FAUNTLEROY WAY APARTMENTS | DESIGN RECOMMENDATION

April 6, 2017

RESPONSES TO EARLY DESIGN GUIDANCE

SUMMARY OF EDG BOARD RECOMMENDATIONS

SIGNAGE CONCEPT PLAN

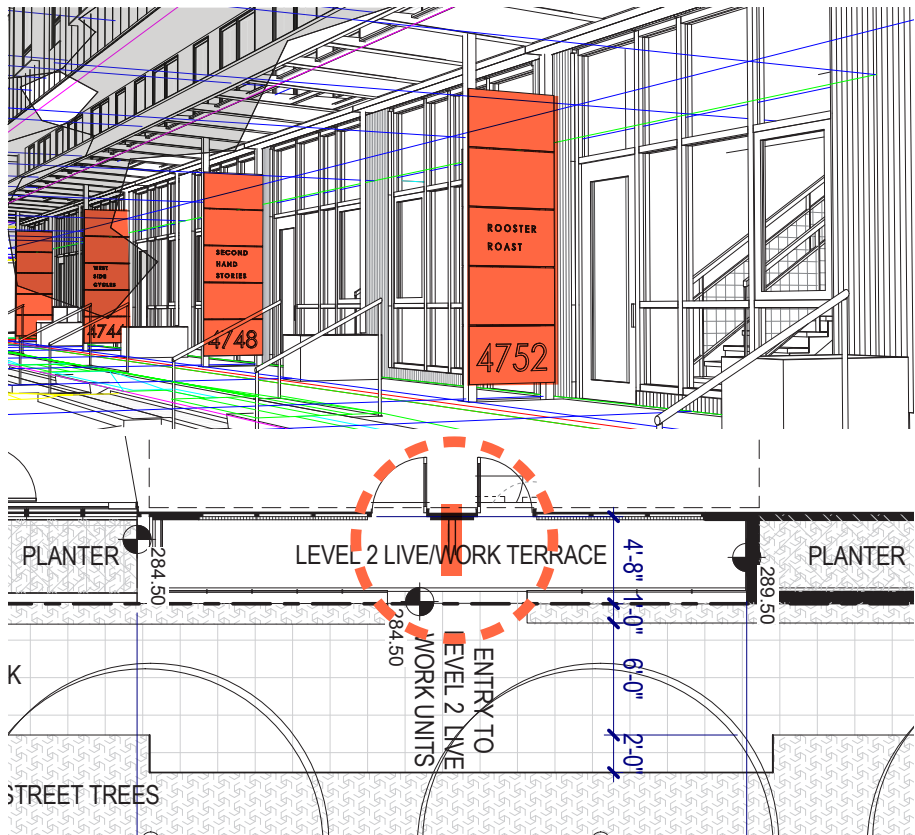
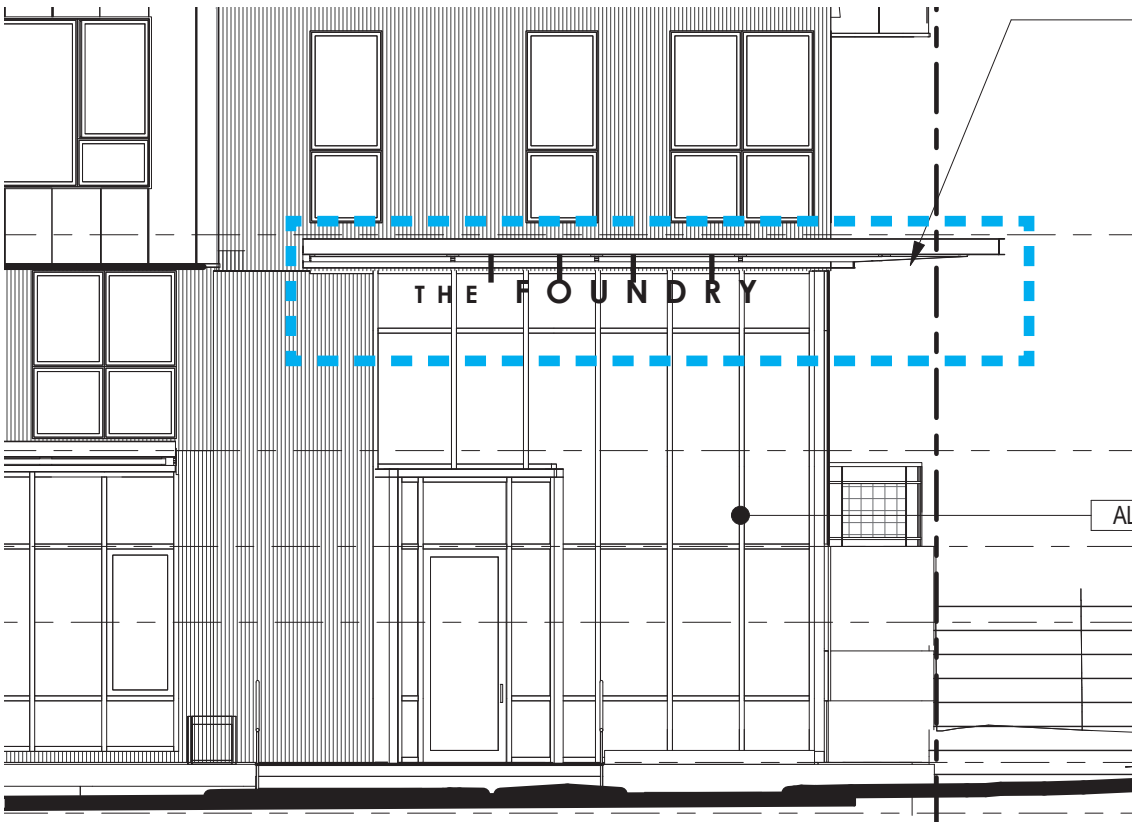
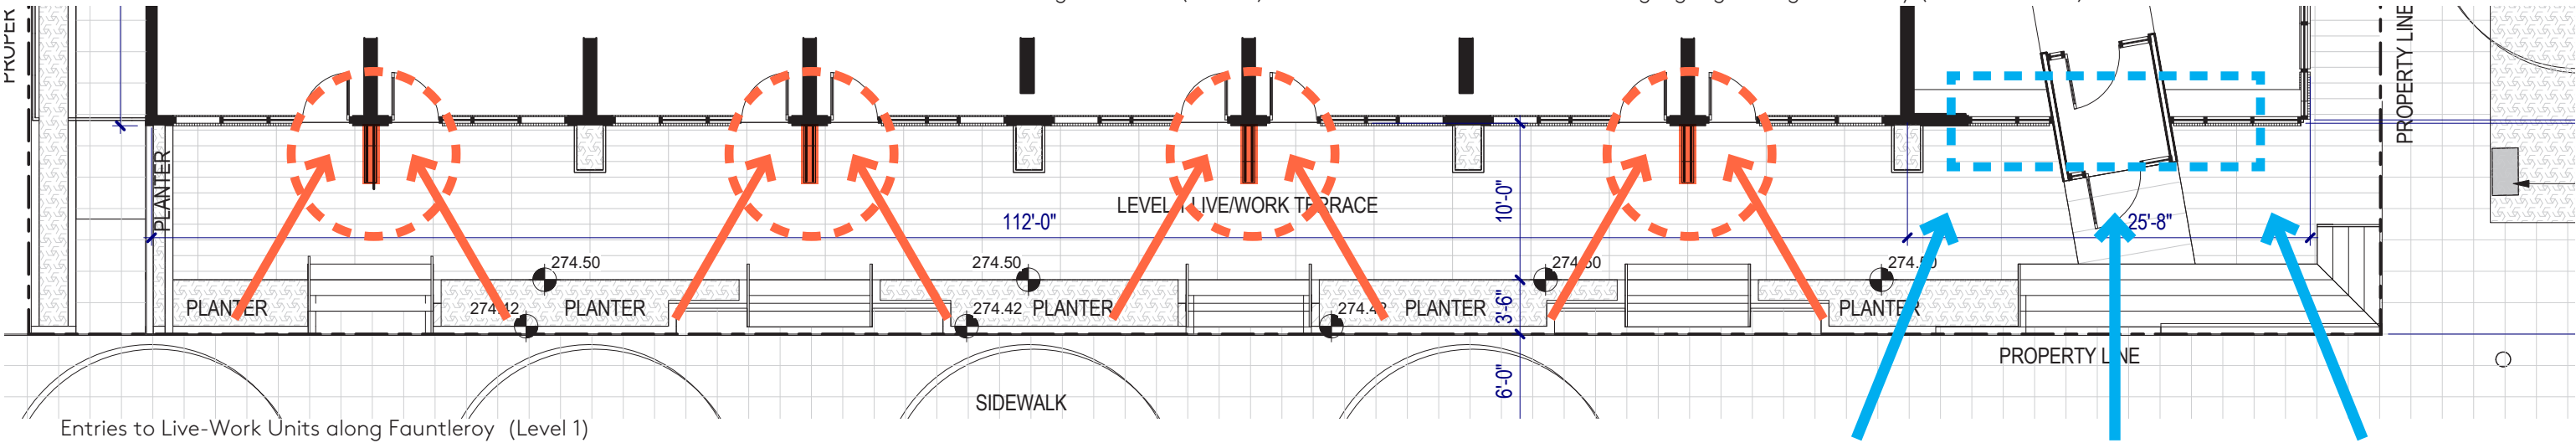
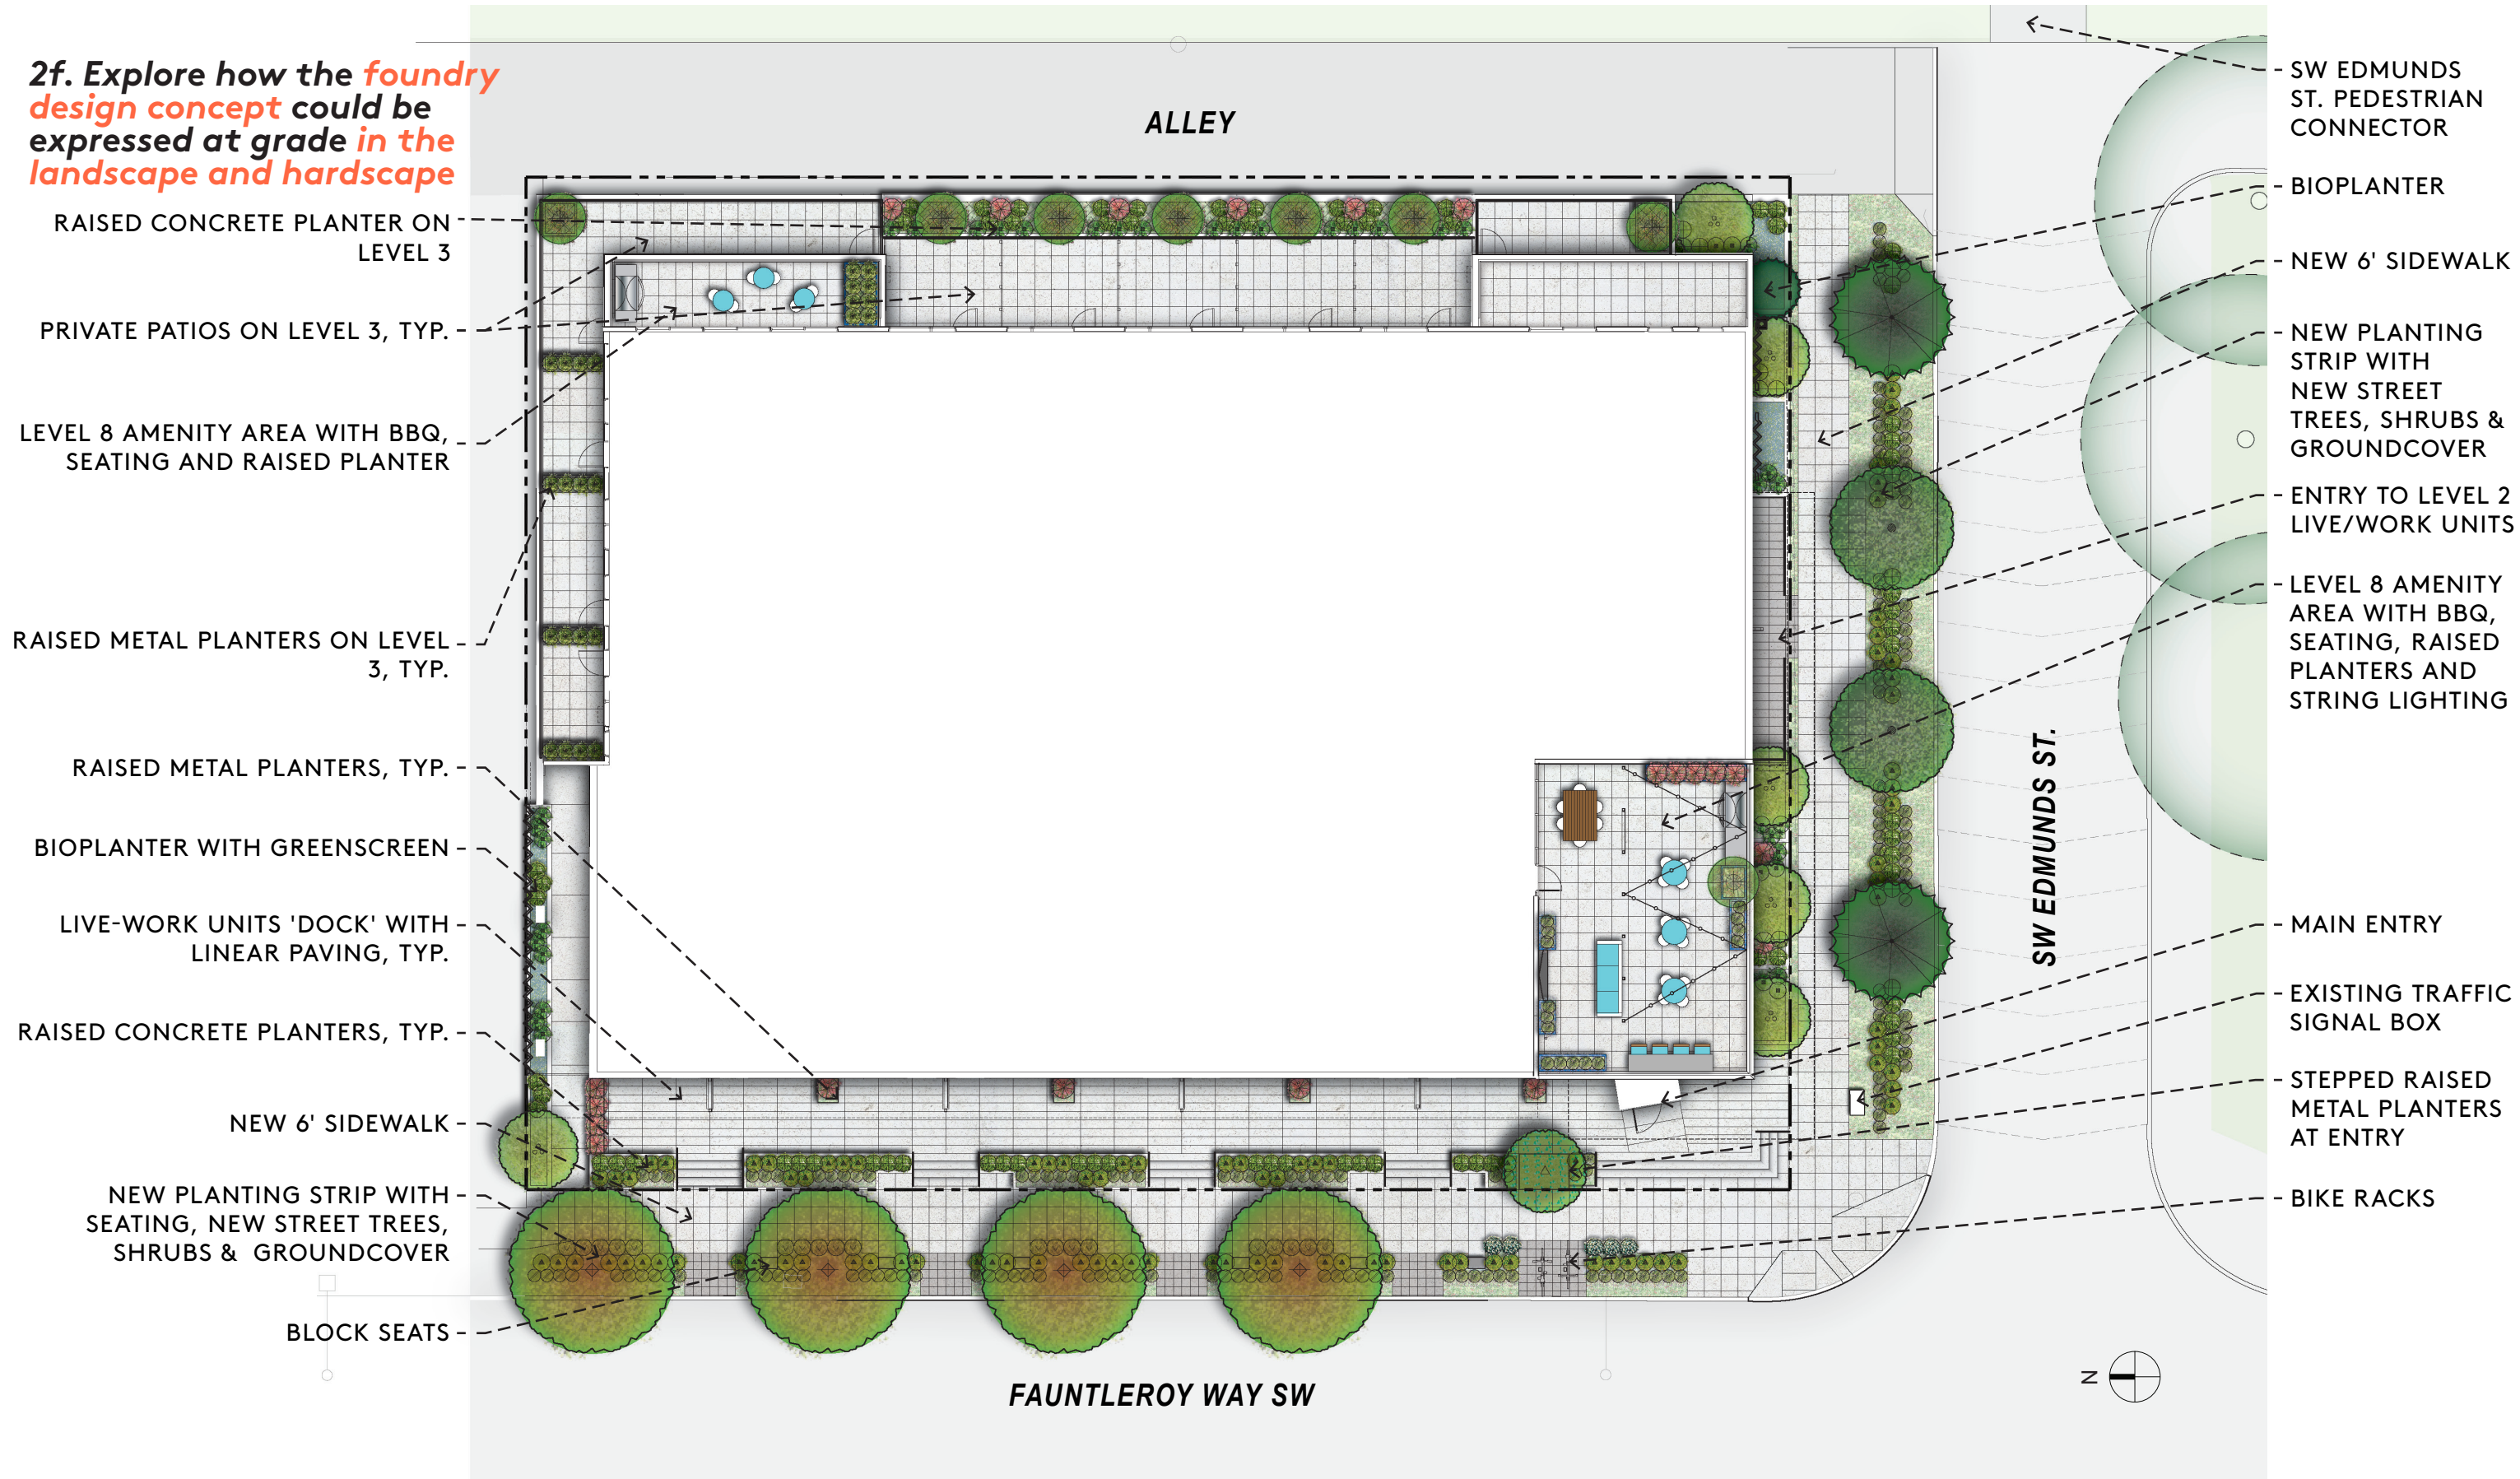
3e. Existing signage in the vicinity is quite large and can have a suburban scale and character. The Board directed the applicant not to look at the existing scale of signage in the neighborhood, but instead to focus on how signage integrates within the scale and composition of the building.

Live-Work Unit Signage:
Signage walls - 4'-0" x 11'-0"
with 4'-0" x 2'-0" customizable piece for business logo/signage to be integrated

Building Signage:
Building Name - 1'-0" tall lettering located above entry at canopy

Sign lighting integrated with canopy supports

Weathered Steel Panels with exposed fasteners
-removable to be customized with logo of live-work business

ROOF PLAN

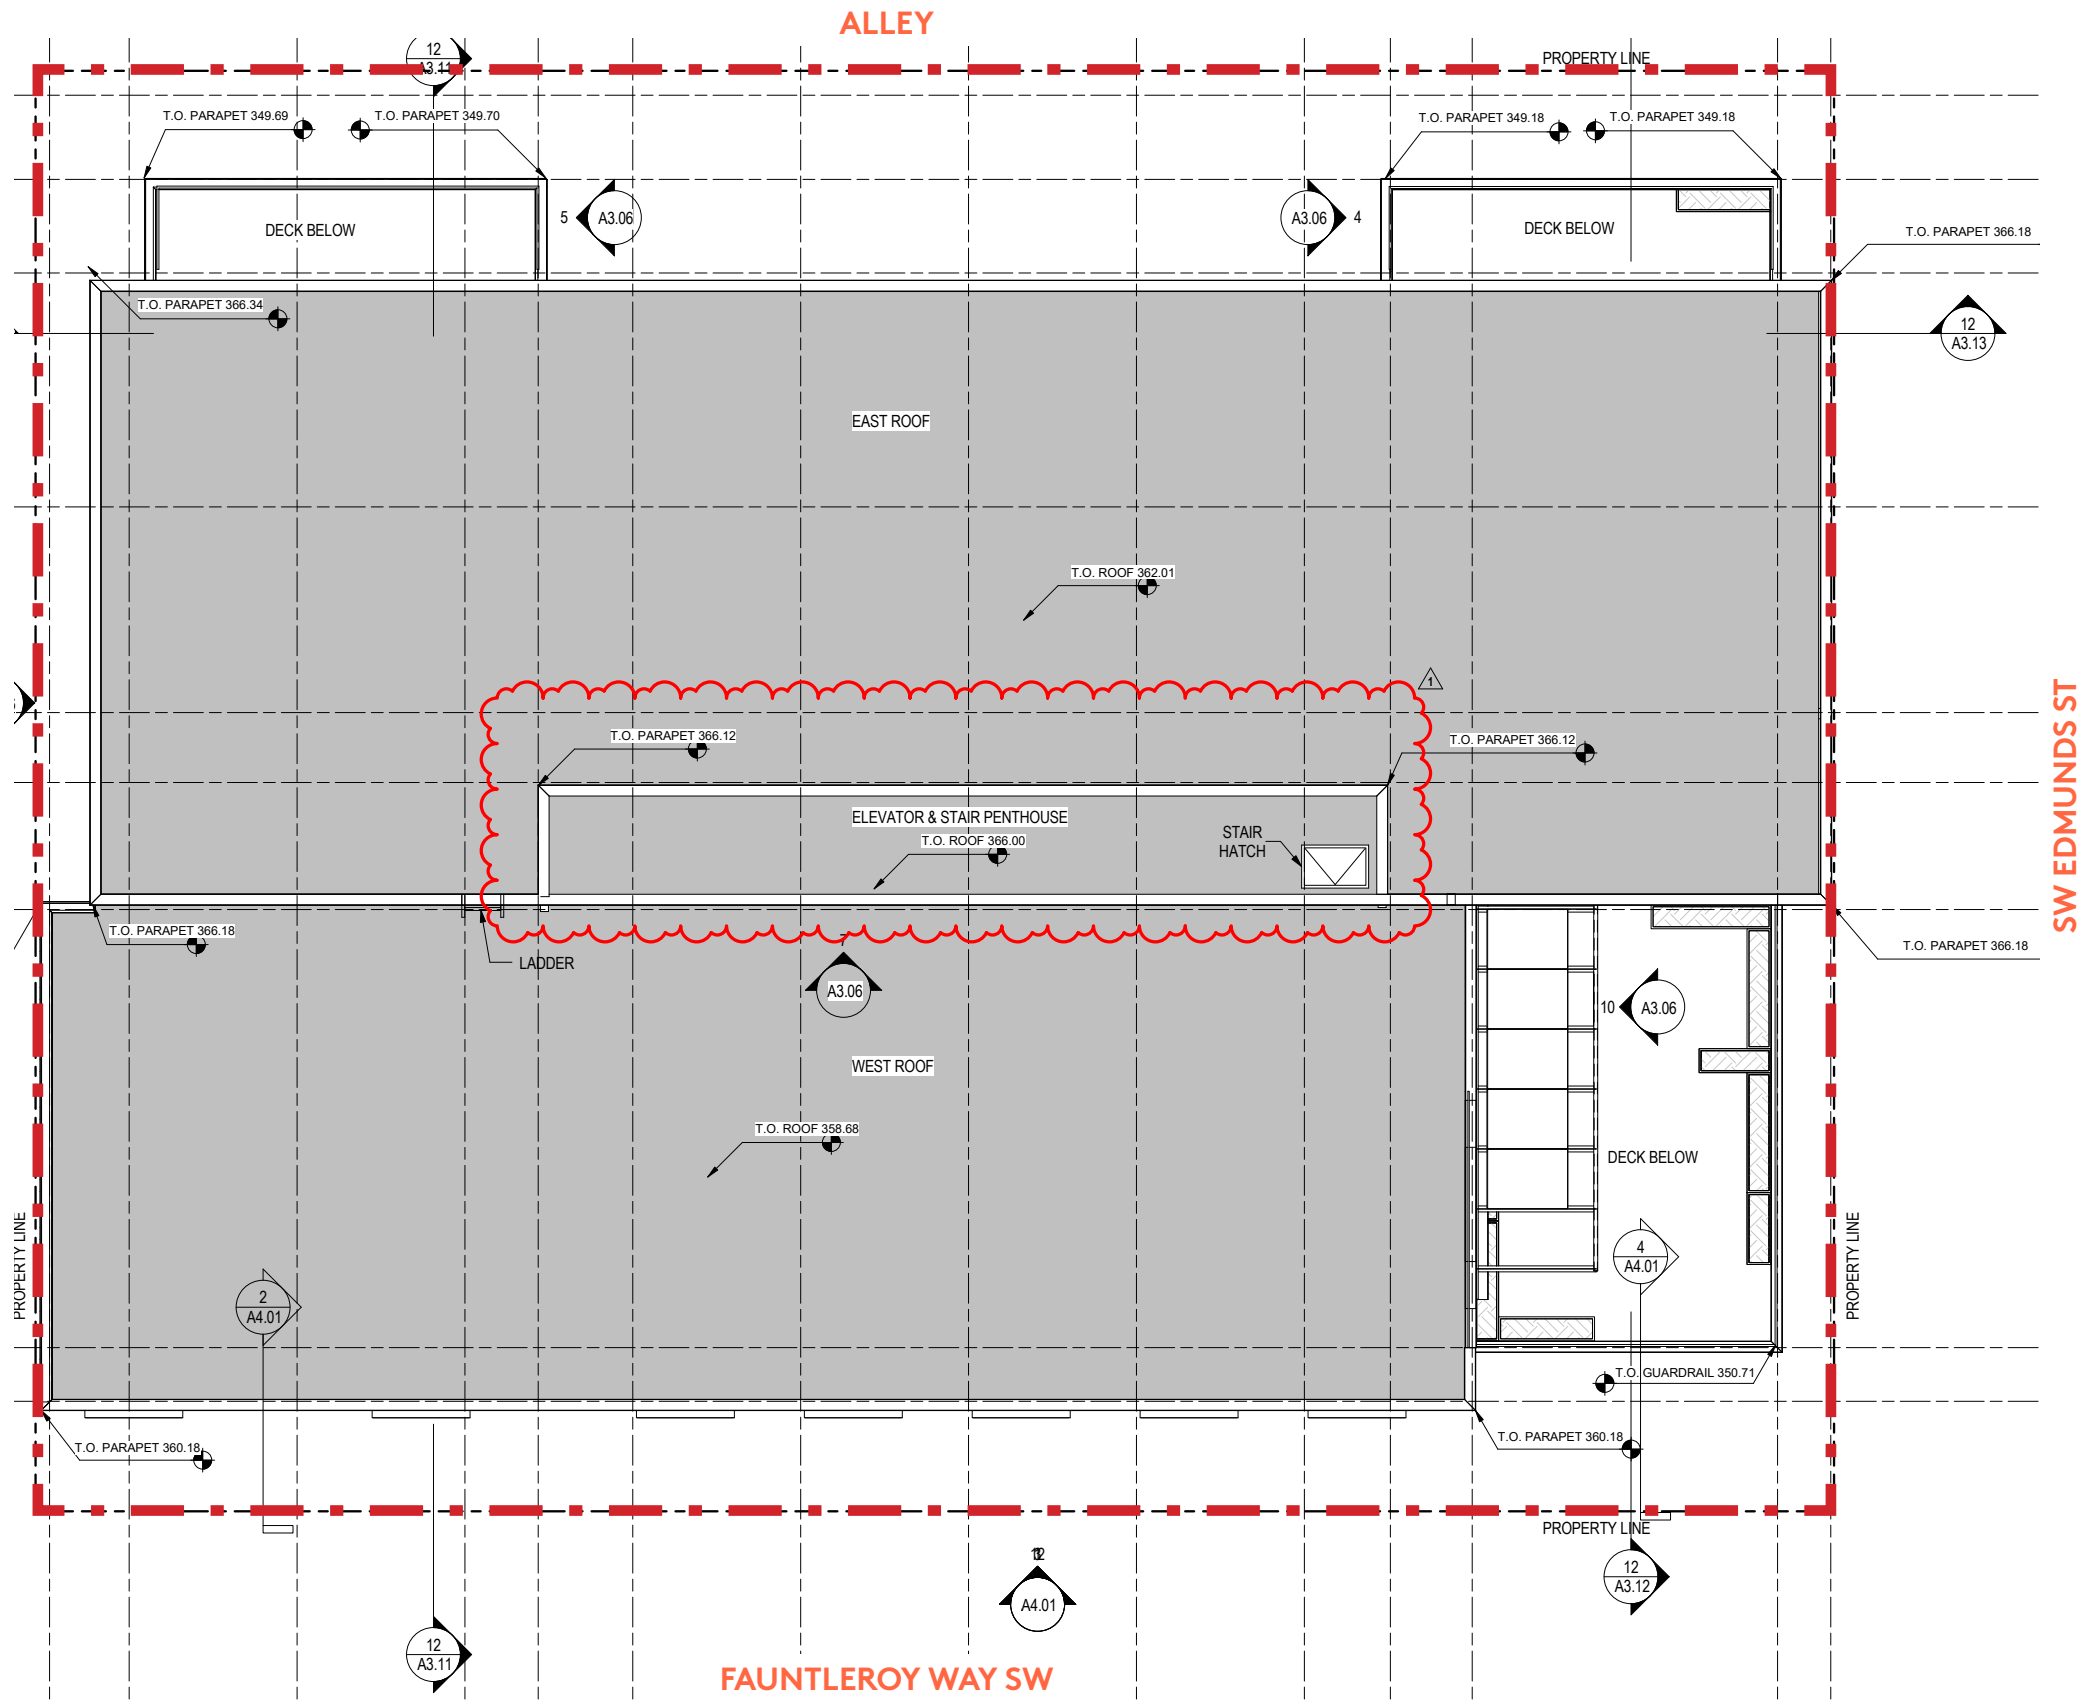
ZONING-2. - Plan sheets A3.01, A3.02, A3.03, A3.04 show the maximum height at 366' 4 1/16" above sea level. If there is mechanical equipment on the roof or a stair penthouse, please label the location of these features on the elevations.

3c. For the recommendation meeting, the applicant should provide additional information on the rooftop design including treatment of mechanical units.
